Docket Nos. 50-325
and 50-324

RE: SCHEDULE FOR THE IMPLEMENTATION AND RESOLUTION OF THE MARK I
CONTAINMENT LONG TERM PROGRAM

EVALUATION BY THE
OFFICE OF NUCLEAR REACTOR REGULATION
OF
SUPPRESSION POOL
TEMPERATURE LIMITS
IN BWR FACILITIES

Figure 1 TYPICAL SRV DISCHARGE DEVICES

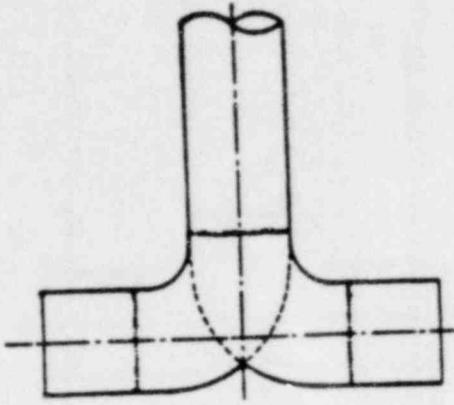
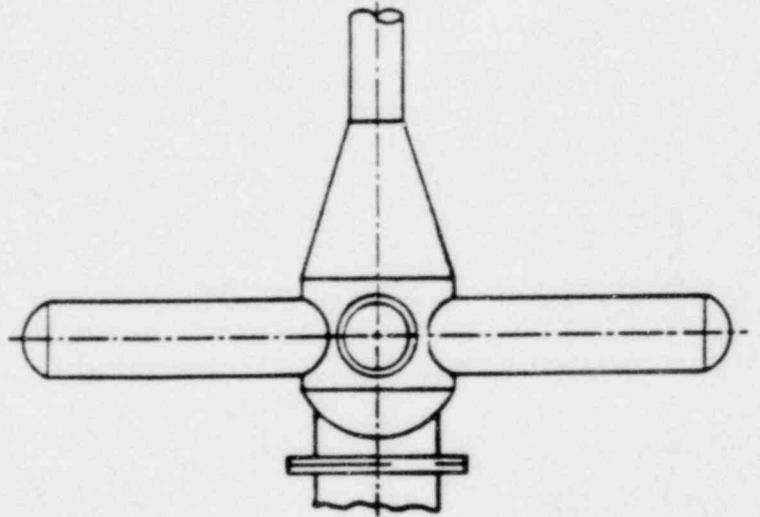
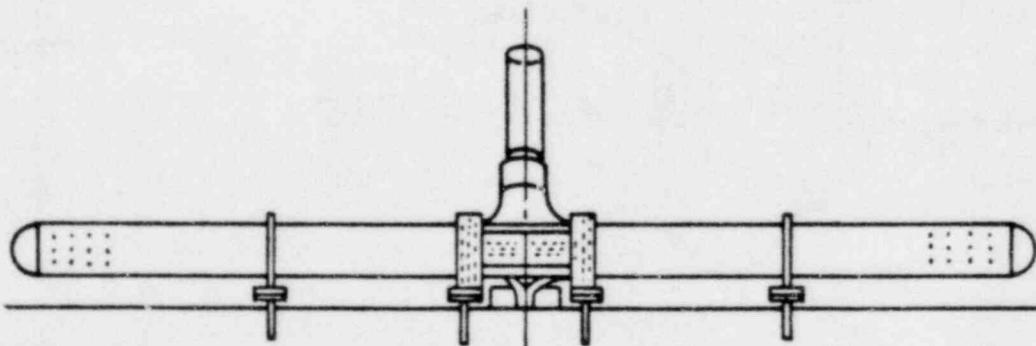
Safety-relief valves (SRVs) in BWR plants are used for reactor vessel pressure relief during either anticipated plant transients or accident situations. These valves are installed on the main steam lines of the reactor system with discharge lines from the valves routed to the suppression pool. When the valves open, the steam is discharged through the piping into the pool where it is condensed. A discharge device, which is affixed to the end of the piping beneath the water level in the pool, serves to mix the discharged air and steam with the pool water. The most common discharge device in use today is the ramshead type, which consists of two 90-degree pipe elbows welded together, as shown in Figure 1.

Figure 1 shows the configuration of a typical cross quencher, which is currently used by all Mark III containments. The cross quencher has four arms with each arm perforated by several rows of small holes. The tip of each arm is plugged and the device measures approximately 10 feet long from tip to tip. Steam flows through the hub, is distributed among the four arms, and is discharged into the pool. The T-quencher device presently being developed for the Mark I plants is similar to the cross quencher except that it has only two arms that are approximately 20 feet long from tip to tip. The quencher device produces a cloud of air or steam mist, whereas the ramshead produces large bubbles.

Based on the improved performance demonstrated for the quencher discharge devices and the uncertainty associated with the definition of the pool temperature limits for ramshead discharge devices, we conclude that the use of ramshead devices in BWR water suppression containment systems is not acceptable for long-term operation. We also conclude that the quencher-type devices provide a satisfactory resolution to the condensation stability concerns and is, therefore, an acceptable replacement.

Figure 2 PLANT OPERATIONAL EXPERIENCE

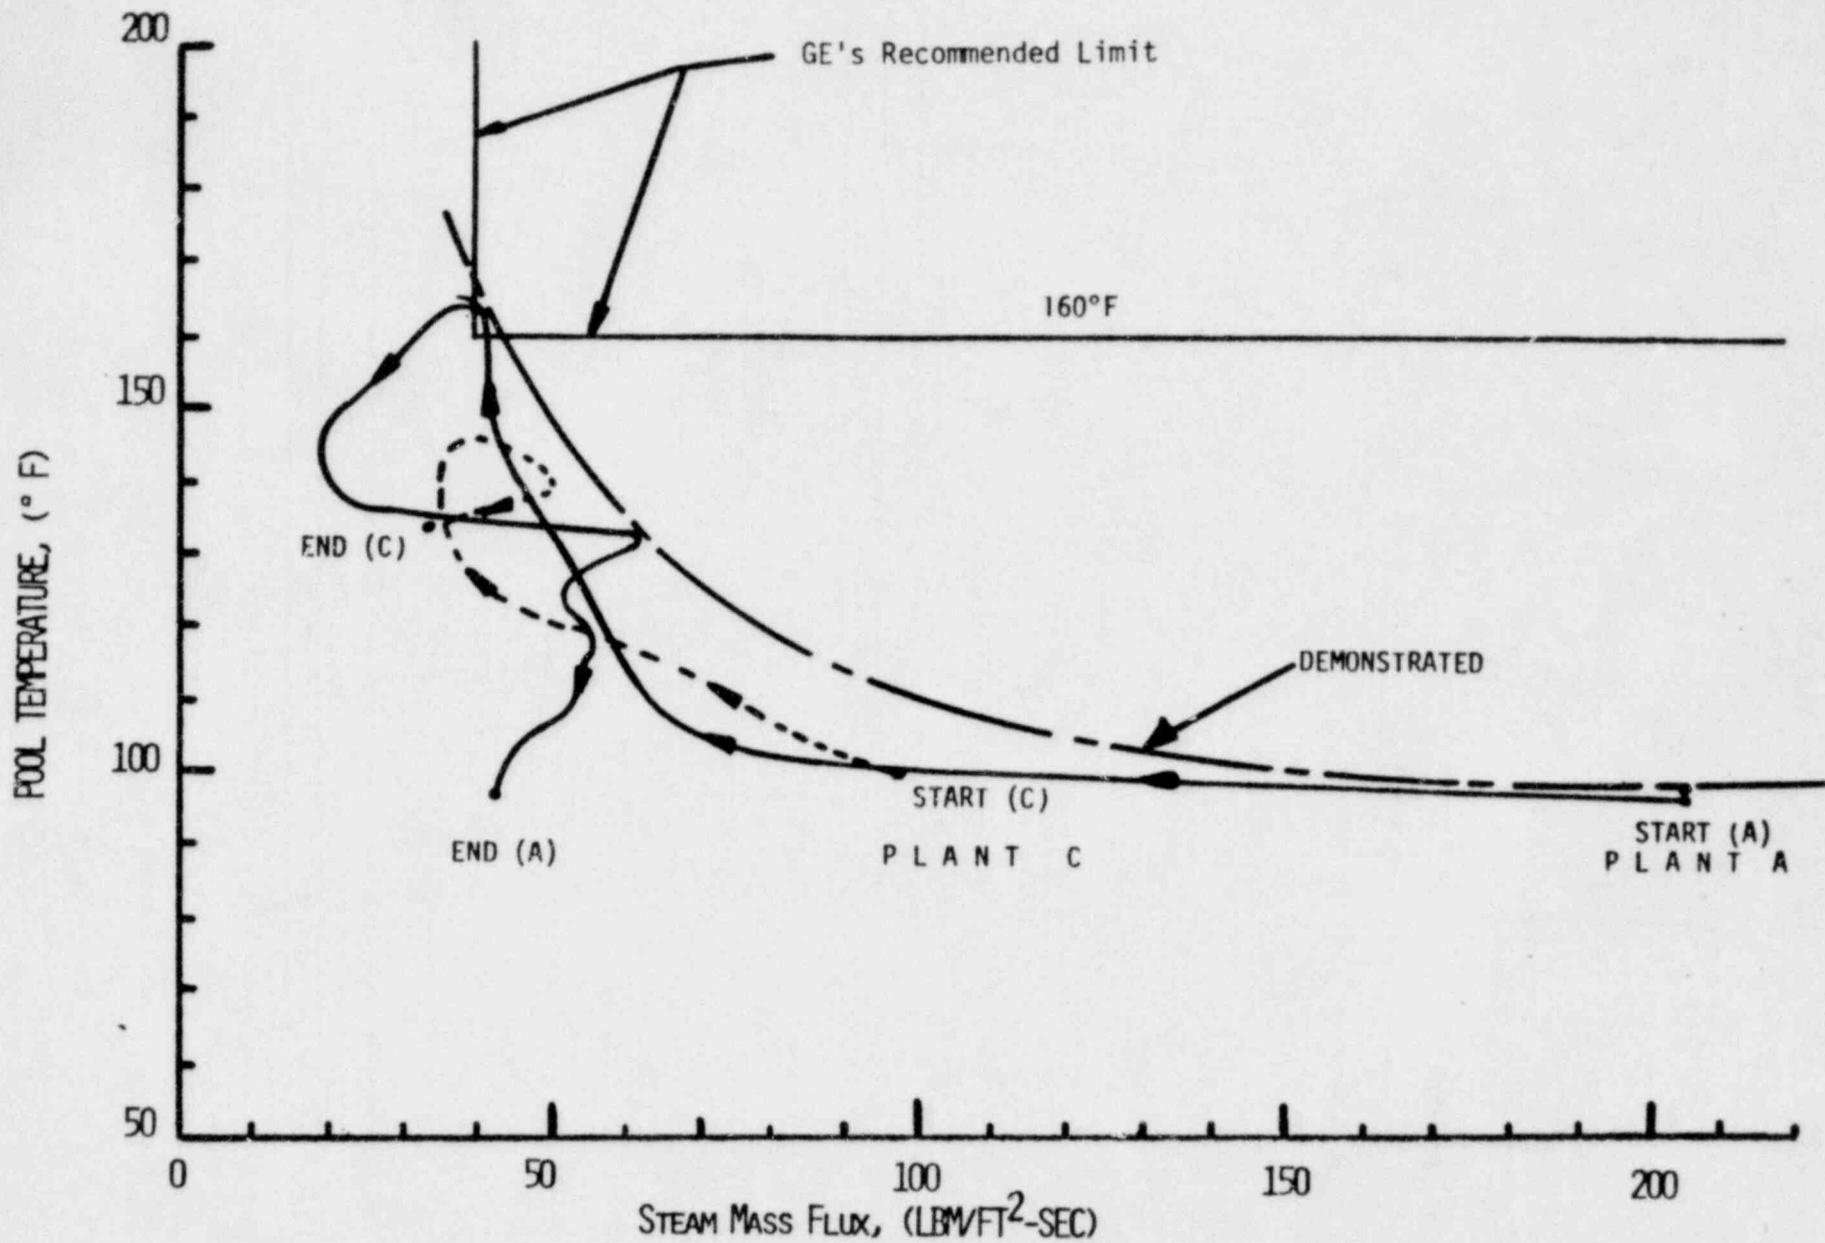
Figure 2 shows the loci of the Plant A and C events on a plot of pool temperature versus SRV steam mass flux during blowdown. It also shows the GE-proposed pool temperature limit. It is clear that the plants experience SRV discharges far below the GE proposed pool temperature limit at virtually all mass fluxes except the lowest. Thus, their experience does not provide support for the higher mass flux at the GE-proposed limit of 160°F.

Figure 3 MARK III STANDARD PLANT SRV WALL PRESSURES

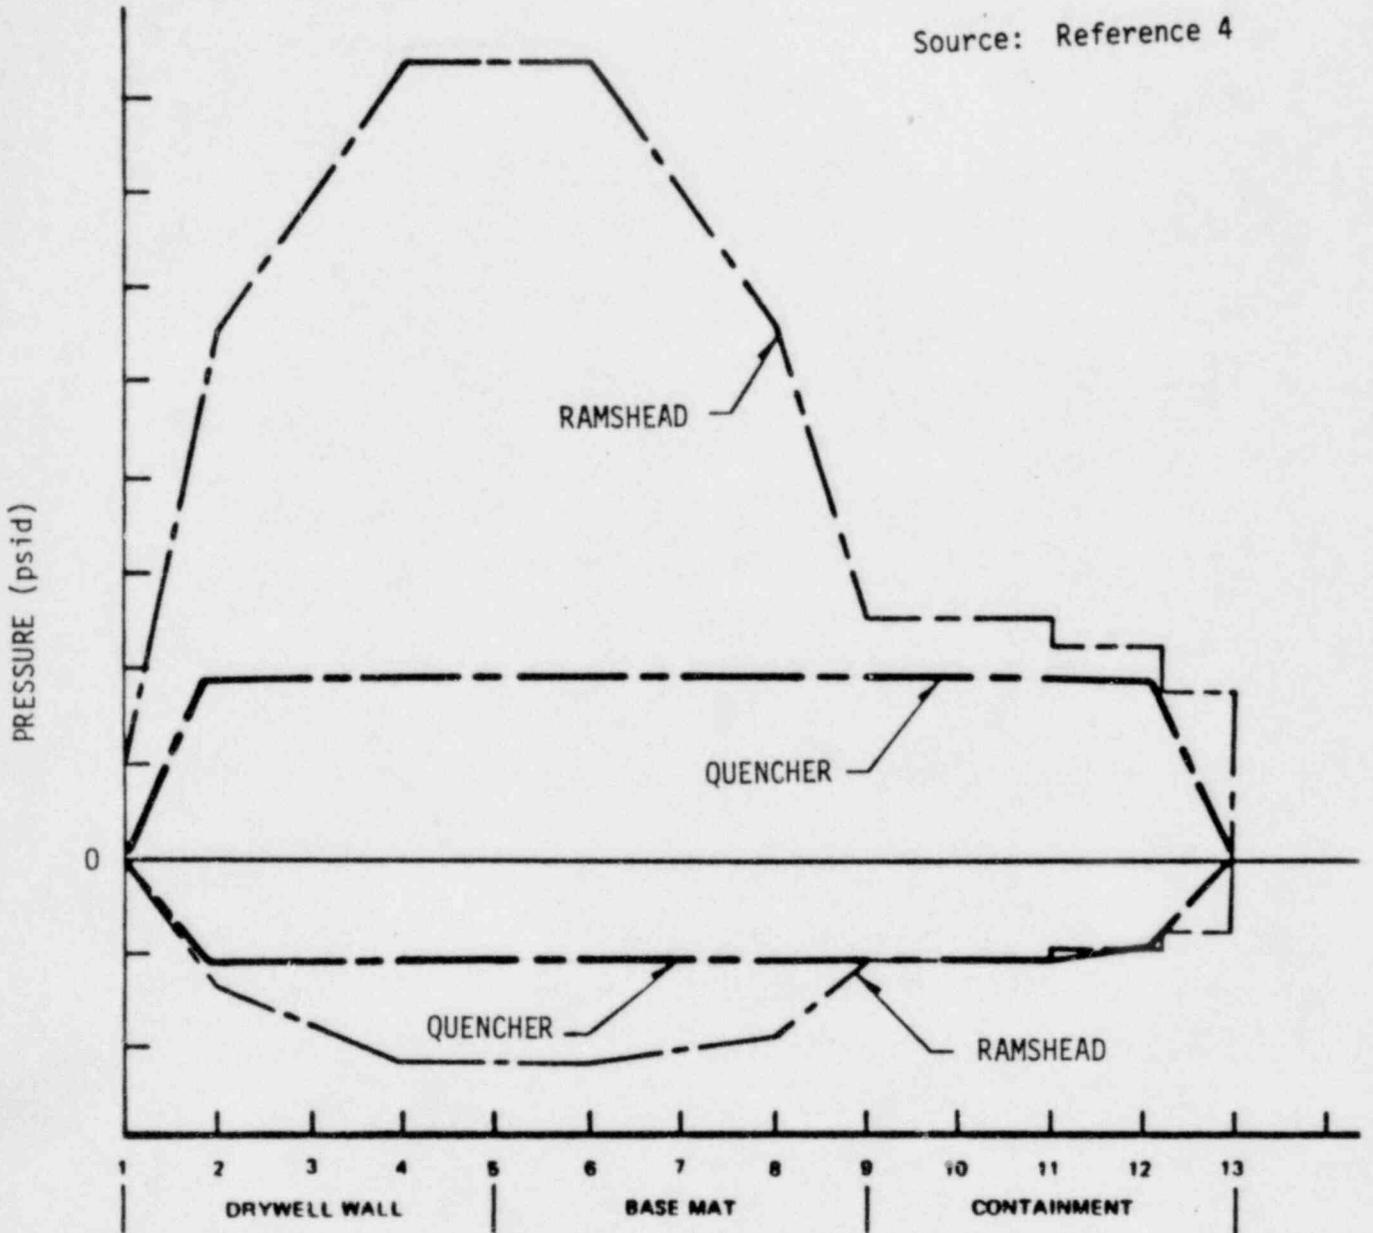
Figure 3 shows the comparison of structural loading functions for quencher and ramshead devices for a 238 GESSAR Mark III plant. Although these loading functions are not applicable for the Mark I design, they demonstrate that the quencher device, in general, substantially reduces the loads on the containment structure with the magnitude of the load reduction being dependent on the quencher configuration and its relative location to the adjacent structures.
